## SUBJECT:

PART I: REPLACEMENT OF O-RING SEALS, PITOT AND STATIC SYSTEM QUICK-DRAIN VALVES

PART II: INSTALLATION OF PITOT AND STATIC SYSTEM QUICK-DRAIN VALVES

PART I: M20F, S/N 680001, 680003 thru 680027, 680029 thru 680033

Static System Quick-Drain Valve Location

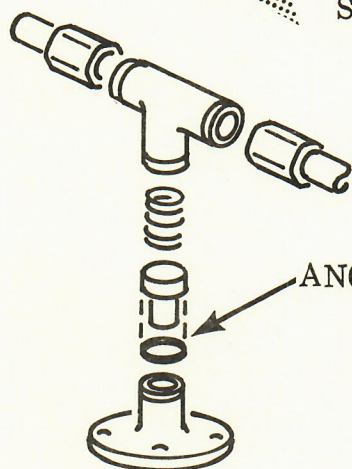
8. Remove tailcone access door.
9. Drill a 3/8-inch diameter hole through bottom tailcone skin, on left side, at lowest point in static system tubing (approx. at center on tailcone access door) as shown in illustration on page 3.

10. Position quick-drain valve assembly with push bottom through hole in skin. Drill four number 40 holes through skin, using valve assembly as guide. Rivet drain valve assembly to tailcone skin with four AN470-AD3 rivets.

11. Cut static tubing and connect tubing to Tee-fitting on drain valve.
12. Leak-check static system according to standard approved practices.
13. Reinstall tailcone access door.

Pitot System Quick-Drain Valve Location

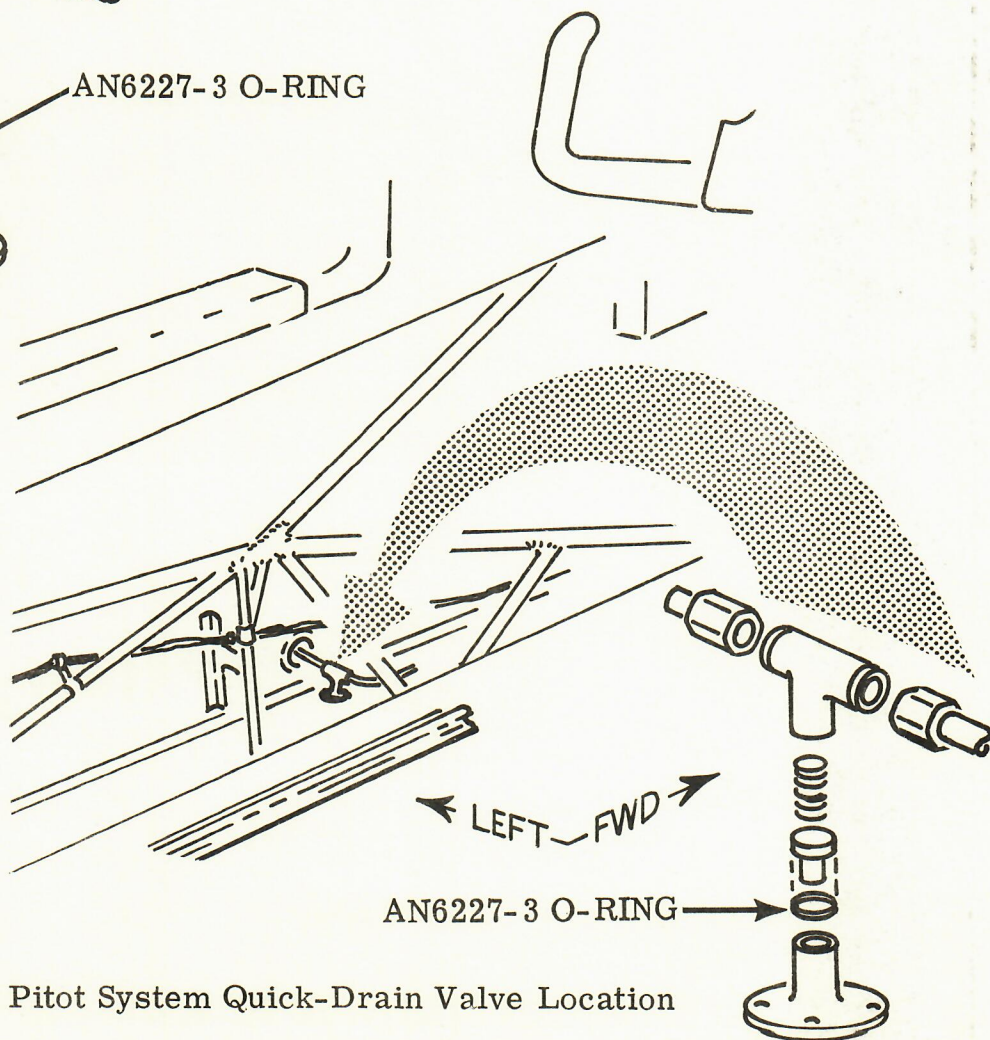
- PART I:
1. Remove pilot seat and left cabin side panel.
  2. Disconnect pitot tubing at quick-drain valve.
  3. Unscrew Tee-fitting from button, and remove spring, clevis pin, and O-ring seal (P/N AN6227-1).
  4. Replace O-ring seal (P/N AN6227-1) with a larger O-ring seal (P/N 6227-3). Reassemble quick-drain valve, threading Tee-fitting in to button three to three and one-half turns. Seal Tee-fitting with Seal-Tite or equivalent sealant.
  5. Reconnect pitot system tubing to Tee-fitting, and leak-check system according to standard approved practices.
  6. Reinstall cabin side panel and pilot seat.
  7. Remove tailcone access door, disconnect static system tubing at quick-drain Tee-fitting, and repeat steps 3 and 4 above.
  8. Reconnect static system tubing to Tee-fitting and leak-check system according to standard approved practices.

2. Remove left cabin side panel.
3. Drill a 3/8-inch diameter hole through left bottom wing skin, between fuselage structure and left wing rib, where pitot line enters cabin. (Refer to illustration on page 3.)

4. Position quick-drain valve assembly with push bottom through hole in skin and drill four number 40 holes through skin, to match holes on drain valve assembly. Rivet drain valve assembly to wing skin with four AN470-AD3 rivets.

5. Cut pitot tubing and connect tubing to Tee-fitting on drain valve.
6. Leak-check pitot system according to standard approved practices.
7. Reinstall cabin side panel and pilot seat.
